Mr. Kenneth D. Schaaf
USNRC, Region II
Enclosure 5
CR-13-00065
RC-13-0141

ENCLOSURE 5

Post-examination comments and facility
responses

RO/ SRO question 57

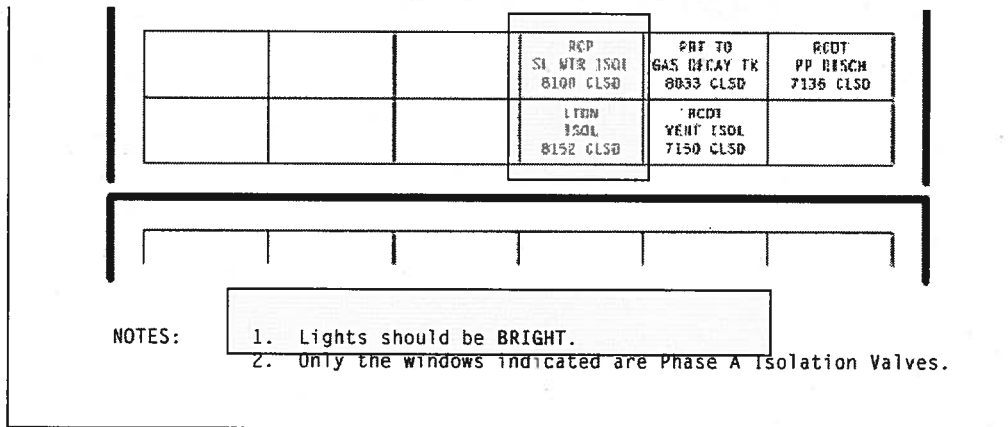
During the examination, one candidate asked the proctor for the panel and the entire set of words as they are read on the status lights. While this does not have a bearing on any candidate's contention of this question, it is included here for completeness. After consultation with the chief examiner, the panel numbers were not given but the sub-bullets were expanded to read as follows (changes are bolded):

The BRIGHT indication as stated in the given condition is actually the condition that indicates that the associated valves have closed properly to isolate containment as shown on page 27 of EOP-1.0.

This was true for both the original and changed version of the question. Thus, the premise of a malfunction is invalid because no information is given that indicates that either a Phase A or Phase B containment isolation failure has occurred. There is, therefore, no correct answer.

V.C. Summer requests that question 57 be deleted from the examination.
